# Access Compliance Report

## Public Rights-of-Way

### (Curb Ramps)

Intersection ID: 31303	Main Street: CANSO_CT	Cross Street: DEERTON_RD	Location: W
ADA ID: 12E1E0819B71	Ramp Type: PerpDiag	Initial Pass/Fail: Fail	Overall Compliance: No
Severity Score: 33.75			
Codes/Mitigation Info/Possible Solution		Field Measurements/Component Compliance

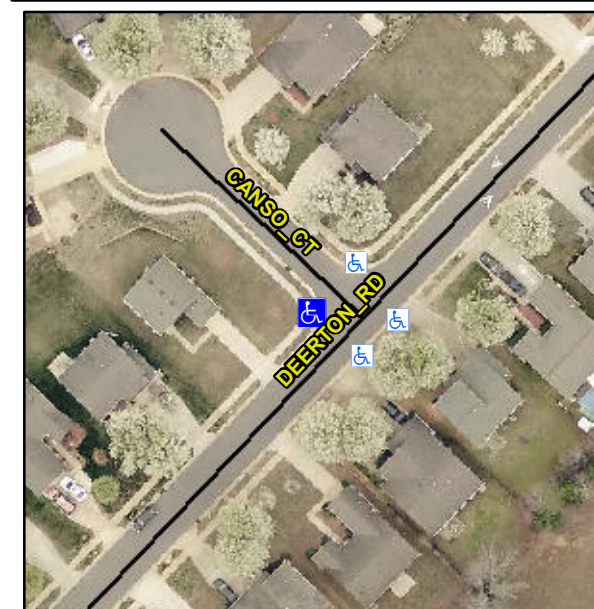
**R304.5.1, R304.5.3**

Compliance	Description	Data	Compliance	Description	Data
N/A	Ramp Length (in)	47.0	Yes	Ramp Slope (%)	7.2
No	Ramp Width (in)	47.5	No	Ramp XSlope (%)	7.9
N/A	Flare Type LT	N/A	N/A	Flare Type RT	N/A
N/A	Flare Slope LT (%)	N/A	N/A	Flare Slope RT (%)	N/A
N/A	Flare Traversable LT?	N/A	N/A	Flare Traversable RT?	N/A
N/A	Landing Length (in)	N/A	N/A	DWS Provided?	N/A
N/A	Landing Width (in)	N/A	N/A	DWS Contrast?	N/A
N/A	Landing Slope (%)	N/A	N/A	DWS Length (in)	N/A
N/A	Landing X Slope (%)	N/A	N/A	DWS Full Width?	N/A
N/A	Landing Curb? (Y/N)	N/A	N/A	DWS Offset (in)	N/A
N/A	Shared Landing?	N/A			
N/A	Gutter Ponding?	N/A	N/A	Gutter Slope (%)	N/A
N/A	Gutter Lip Ht (in)	N/A	N/A	Gutter X Slope (%)	N/A
N/A	Painted X Walk1?	No	N/A	Painted X Walk2?	No
	X Walk 1 Direction	To S		X Walk 2 Direction	To N
N/A	X Walk 1 Width (in)	N/A	N/A	X Walk 2 Width (in)	N/A
	X Walk 1 Slope (%)	0.3		X Walk 2 Slope (%)	6.4
	X Walk 1 X Slope (%)	6.4		X Walk 2 X Slope (%)	2.3

**Remove & Replace Curb Ramp With Two New Directional Ramps or Equivalent.**
